Subject: Duke Energy Carolinas, LLC
William States Lee III Nuclear Station - Docket Nos. 52-018 and 52-019
AP1000 Combined License Application for the William States Lee III Nuclear
Station Units 1 and 2
Response to Request for Additional Information Letter No. 120 (eRAI 7570)
Ltr#: WLG2014.08-01

Reference: Letter from Brian Hughes (NRC) to Robert Kitchen (Duke Energy), Request
for Additional Information Letter No. 120, Related to SRP Section 03.07.02 –
Seismic System Analysis for the William States Lee III Units 1 and 2
Combined License Application, dated July 11, 2014 (ML14192B073)

RAI 03.07.02-3 (eRAI 7570)

Reference NRC RAI Number(s): 03.07.02-3 (eRAI 7570)

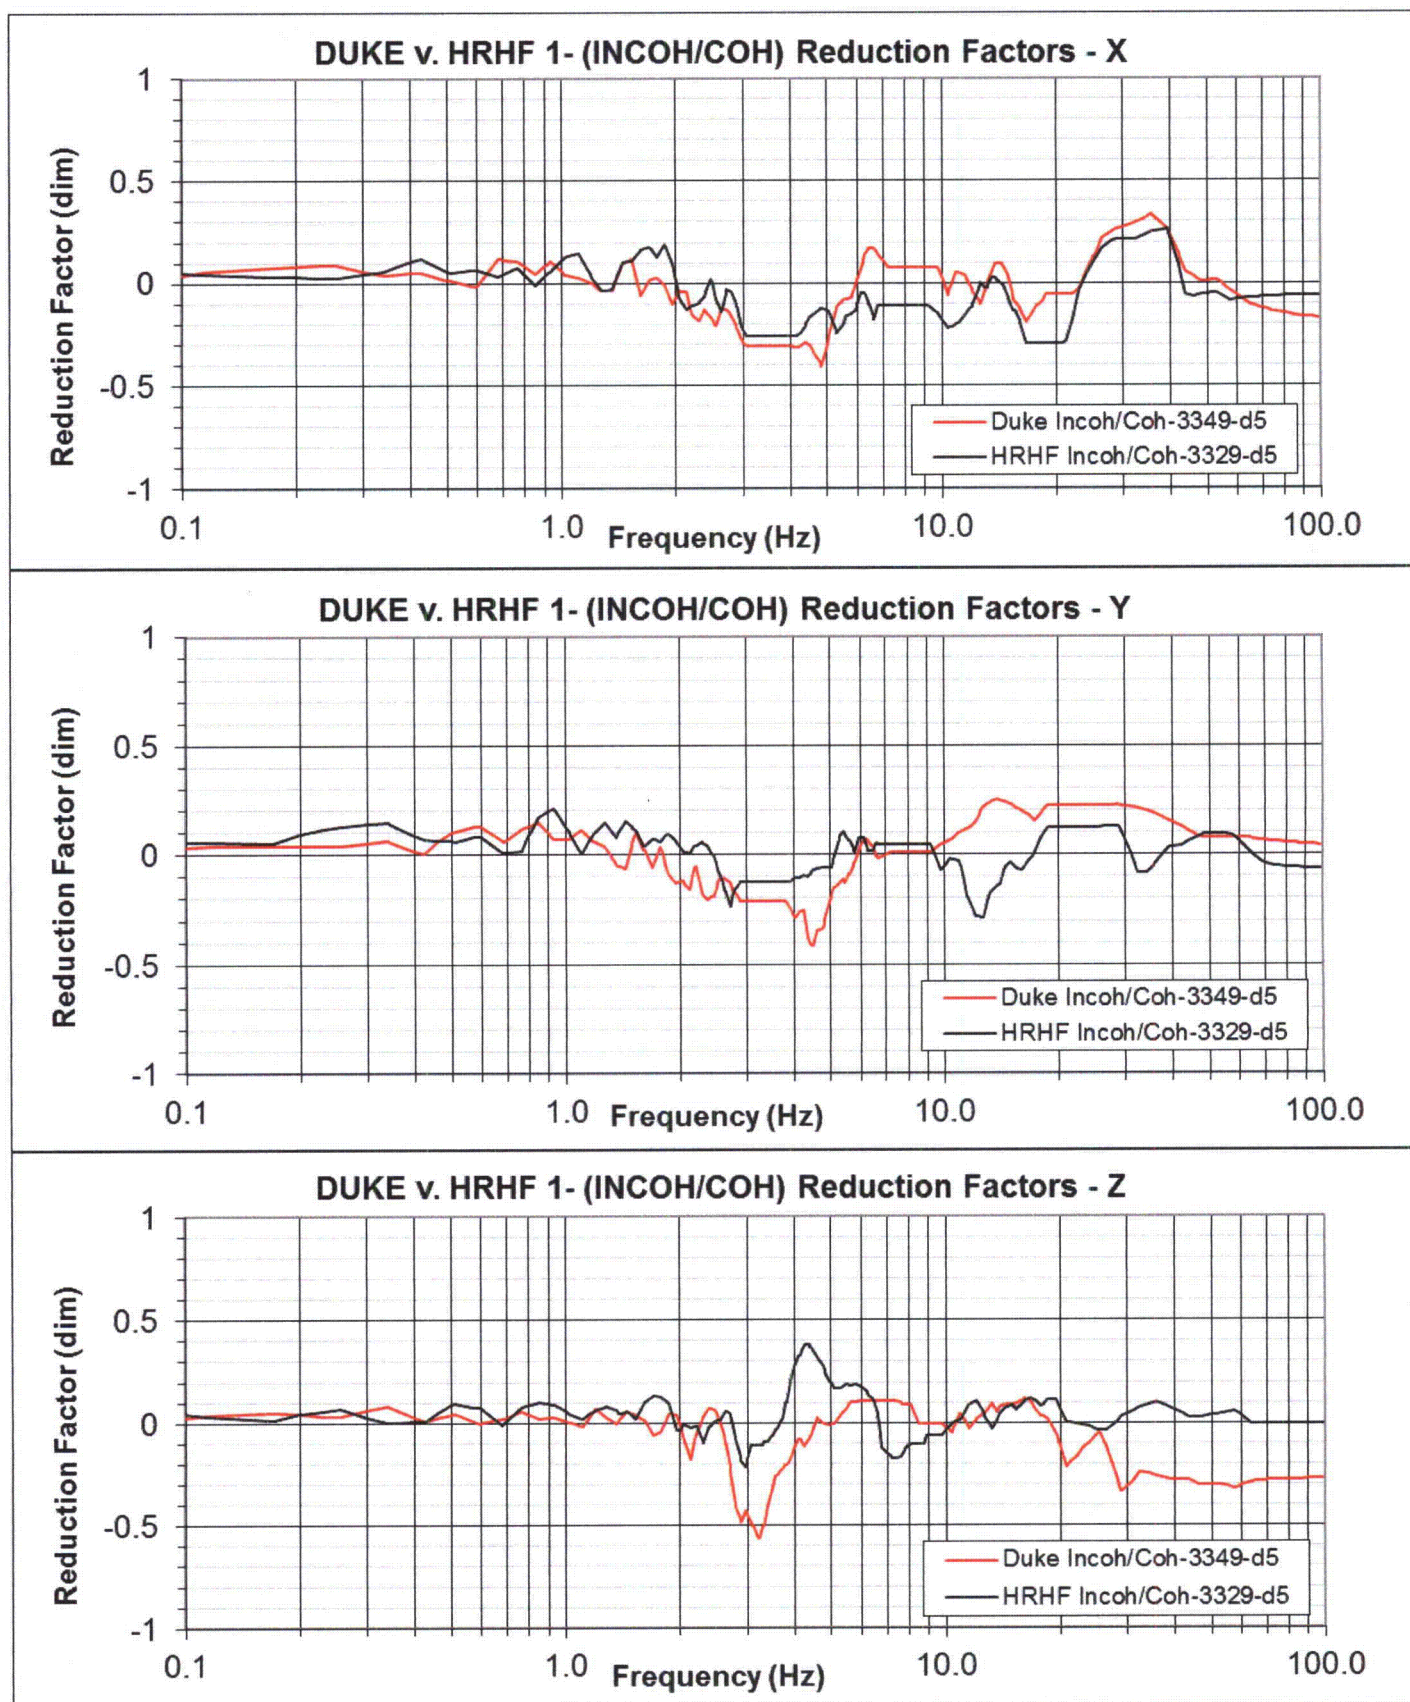
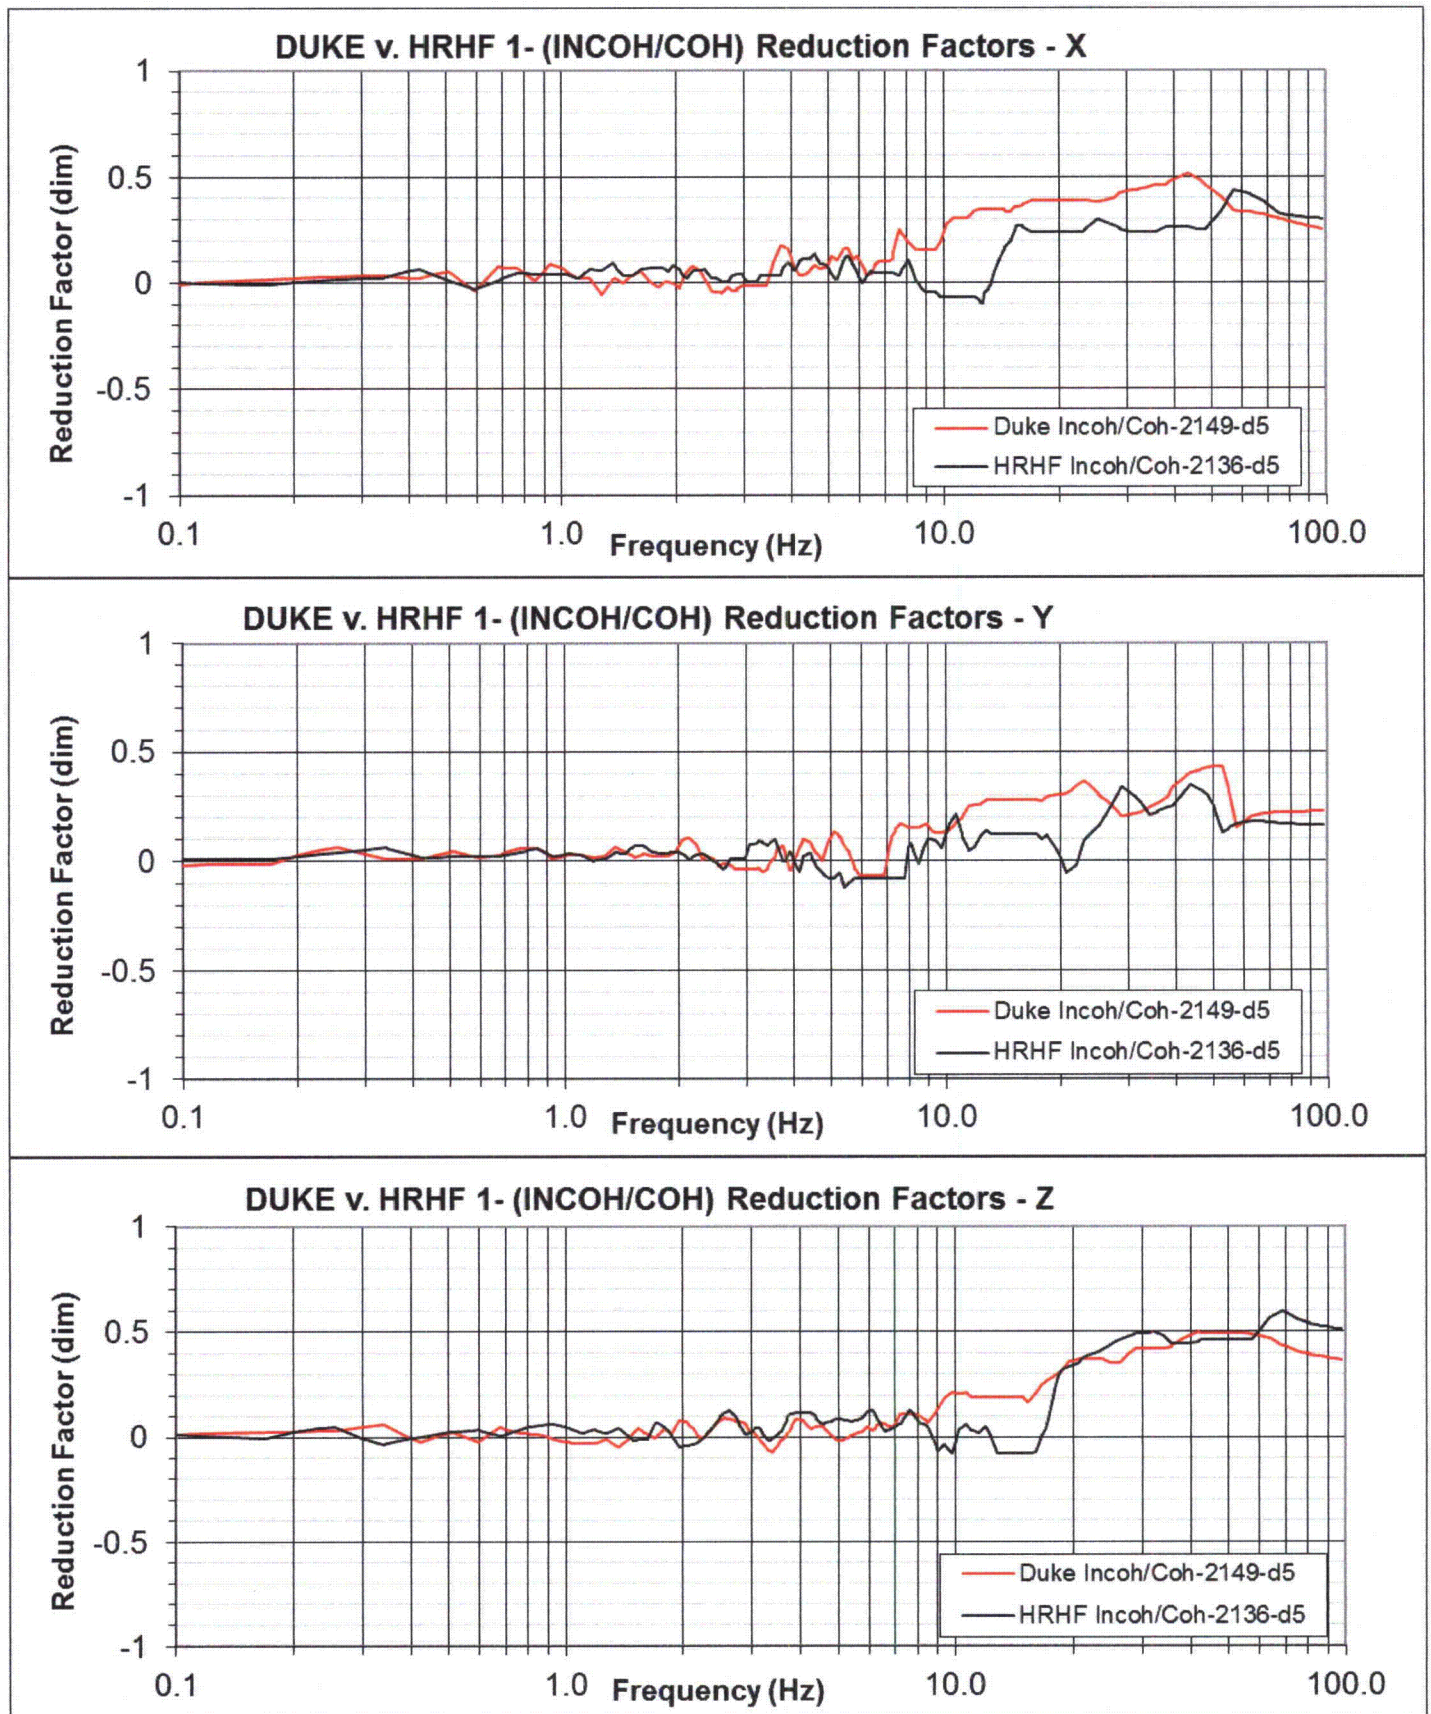
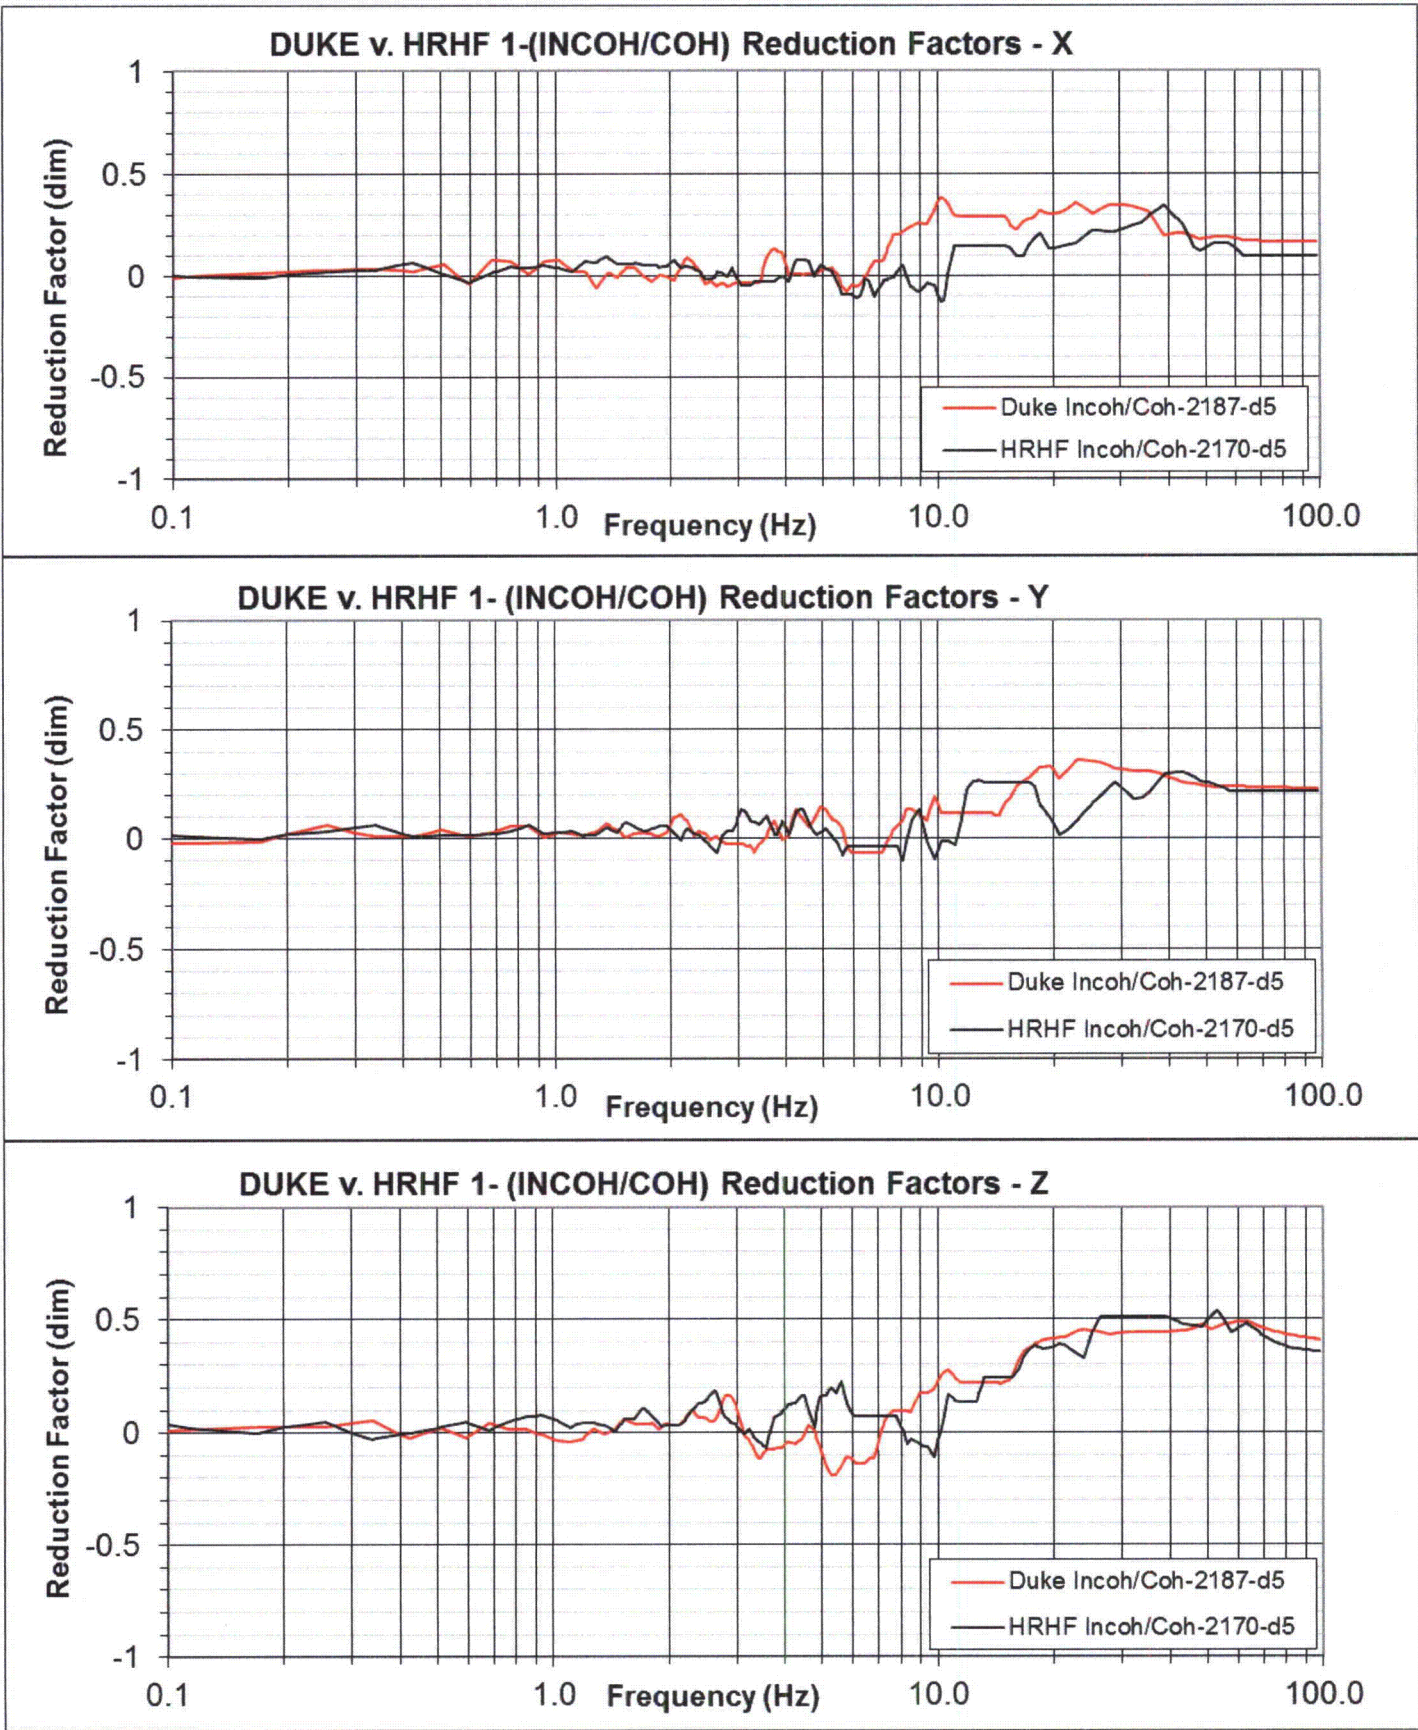
Staff review of Duke Ltr#WLG2014.01-02 Appendix A to WLG-GW-GLR-815 Rev 0 finds that while the graphical comparisons are helpful in assessing the impacted frequency ranges due to incoherency, they do not indicate the percentage reduction of coherent motion; $[1 - (\text{incoherent response} / \text{coherent response})] \times 100\%$.

To assist the staff in its review of the site-specific implementation of seismic motion incoherency, the applicant is requested to quantify the range of reductions to coherent motion for both the AP1000 HRHF and site-specific evaluations.

The following summarizes the data presented below in Figures 03.07.02-3-1 through 03.07.02-3-9:

- The Duke Lee and AP1000 TR115 FRS coherent reductions are comparable for the NI nodes and directional FRS presented. Reduction factors trend similarly in shape and magnitude, and reduction factor differences, both positive and negative occur for both Duke Lee and AP1000;
- Duke Lee and AP1000 TR115 FRS incoherent reduction factor differences are influenced by model refinements to the NI20u finite element model for Duke Lee versus the AP1000 NI20r model to reflect the latest design; and;

- Rock profile differences between the AP1000 generic hard rock profile and the site-specific Duke Lee concrete/rock profiles, i.e., lower shear wave velocity (V_s) in the 50' below basemat.

In conclusion, the Duke Lee and TR115 FRS coherent reductions are similar given the variations in Duke Lee versus AP1000 site conditions and the seismic model updates.
